**PLAN COMMISSION
MEETING NOTICE AND AGENDA
Thursday, November 20, 2025
6:00 PM**

Pewaukee City Hall Common Council Chambers
W240N3065 Pewaukee Road, Pewaukee, WI

- 2.3 July 17, 2025
3. Items for Discussion and Possible Action
 - 3.1 Discussion and Action Regarding the Site and Building Plans for The Glen at Springdale for a Multi-Family Residential Development Upon Property Located at W220 N2475 Springdale Road as Requested by Cornerstone Development (PWC 0916997)

- 3.2 Discussion and Action Regarding the Site and Building Plans for Lake Country Eye Surgery Center for an Ambulatory Surgery Center Upon Property Located at W238 N1670 Busse Road (PWC 0954998013)

C-301

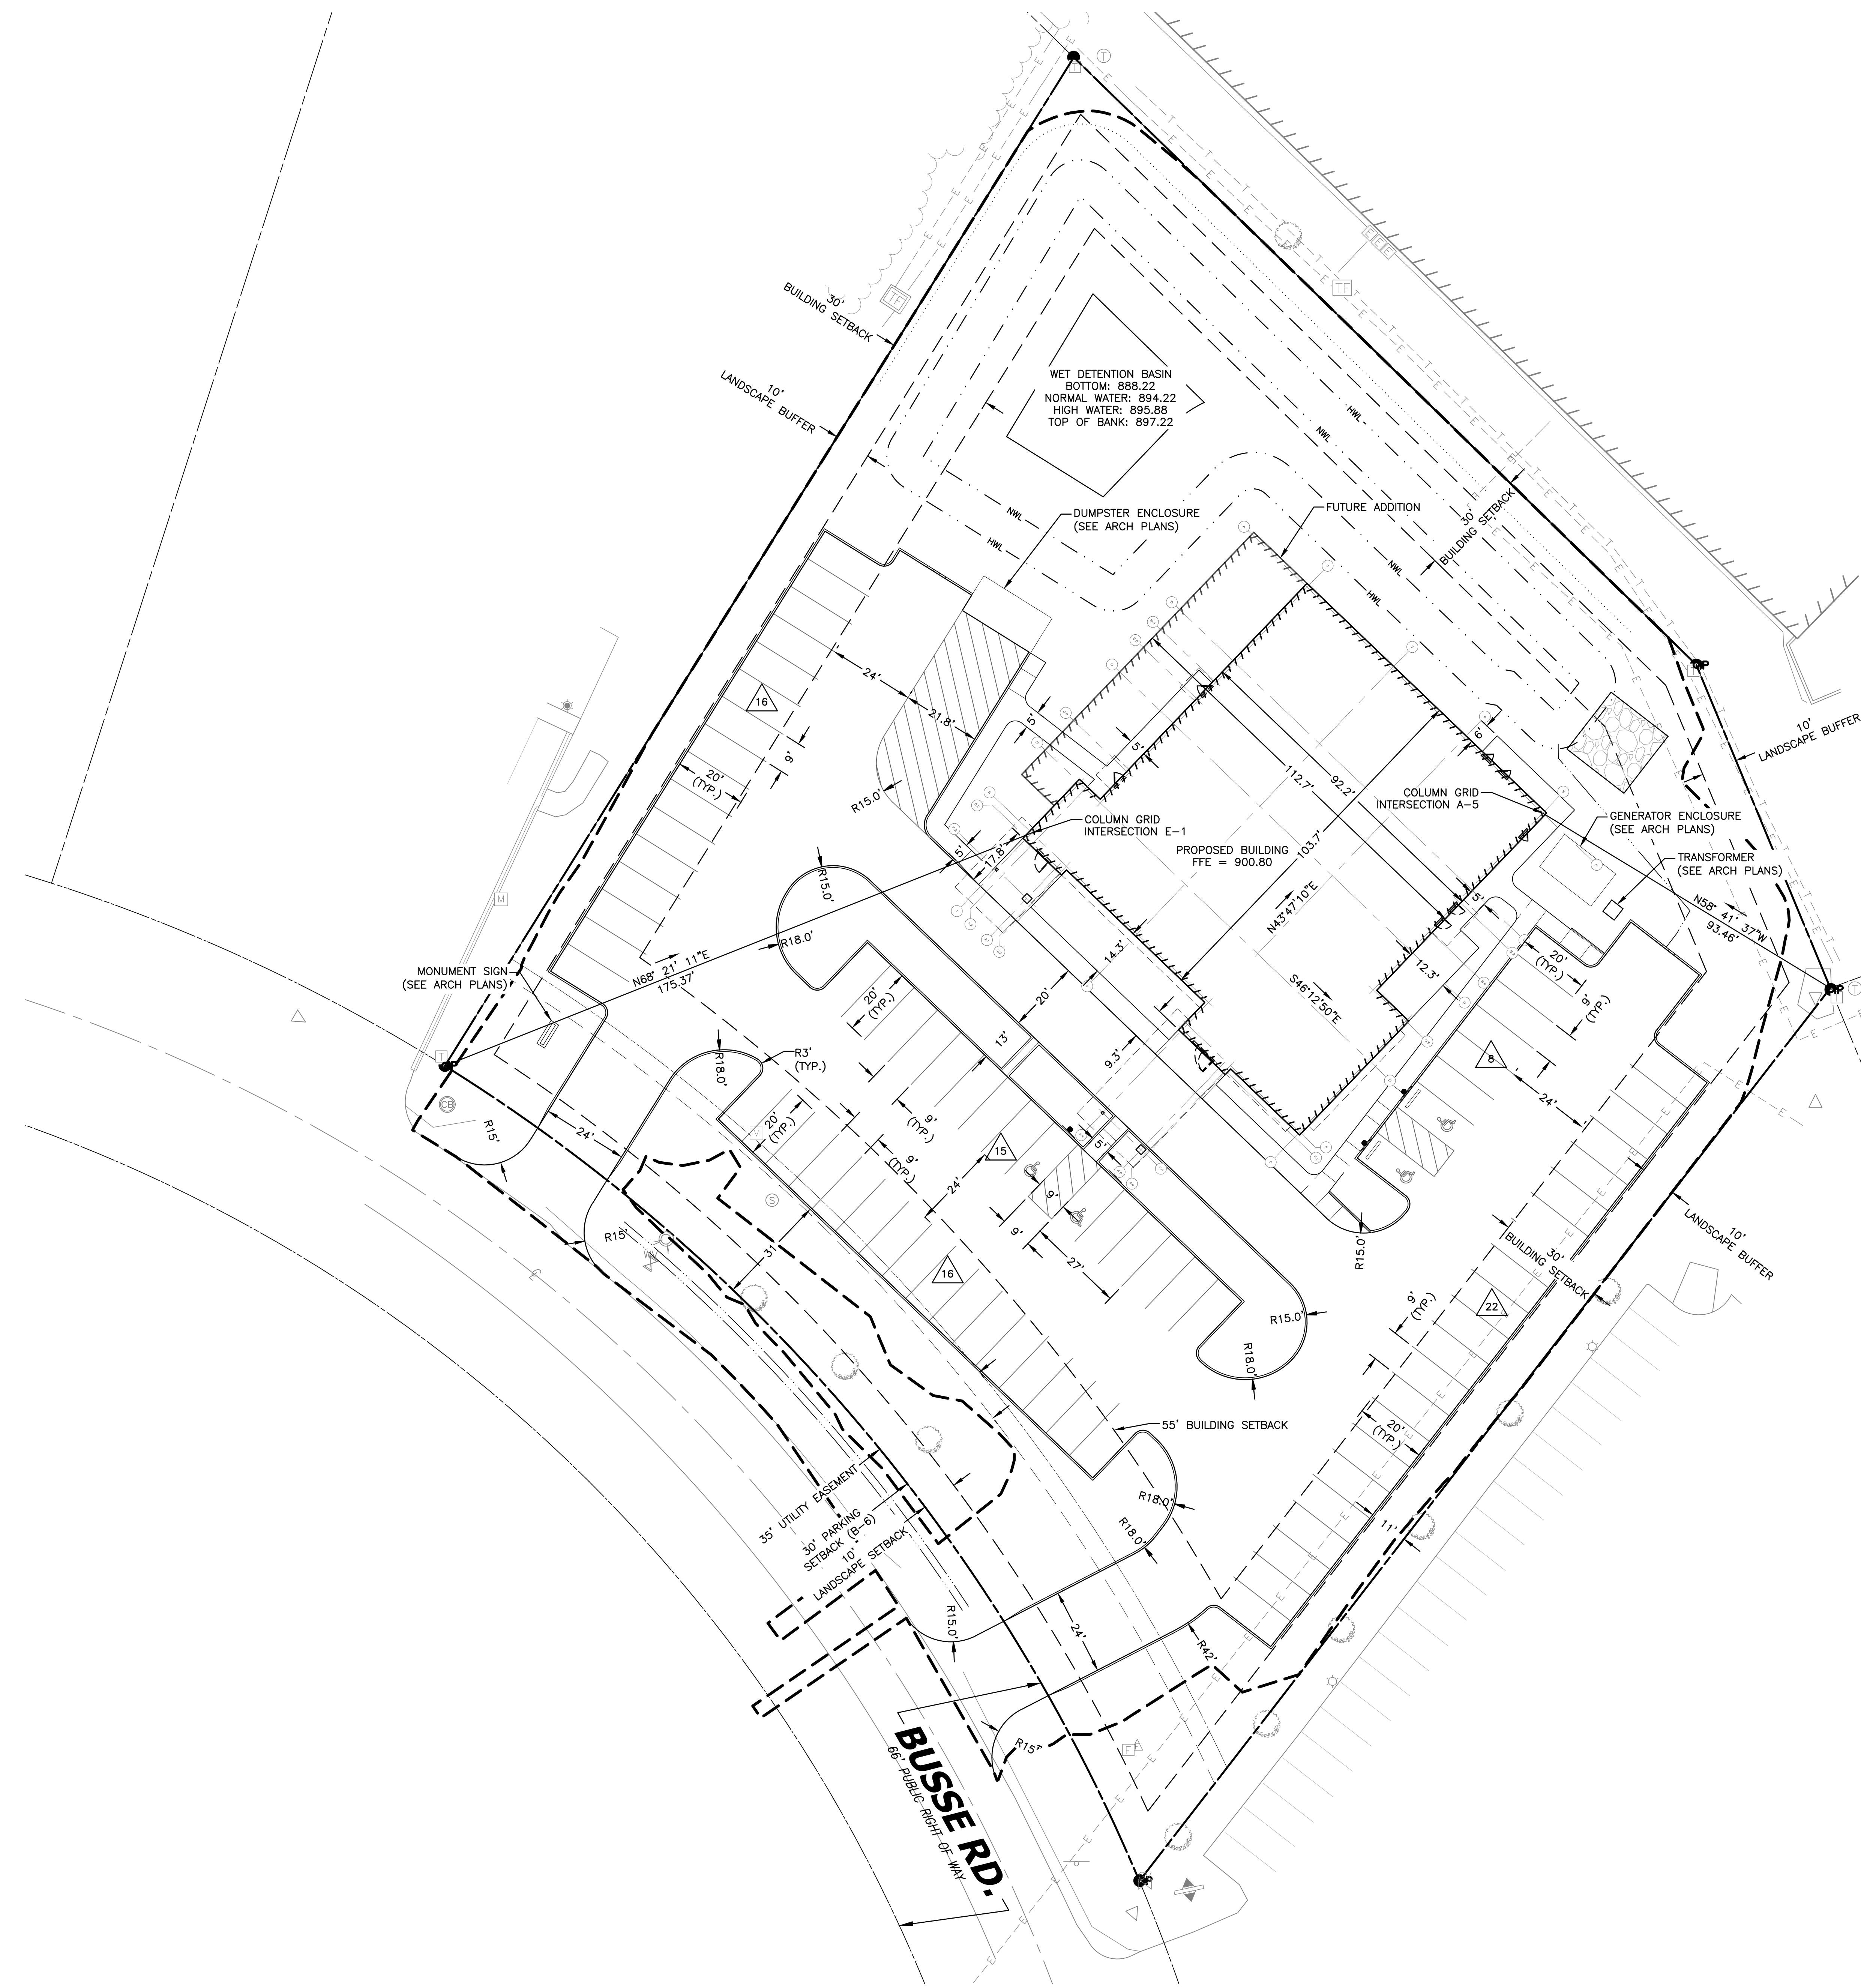
1. On the Site Plan, Sheet C-300, please include a site data table consisting of site information such as lot size (square feet and acres), existing and proposed impervious surface, greenspace, required and proposed setbacks, and peak building height.
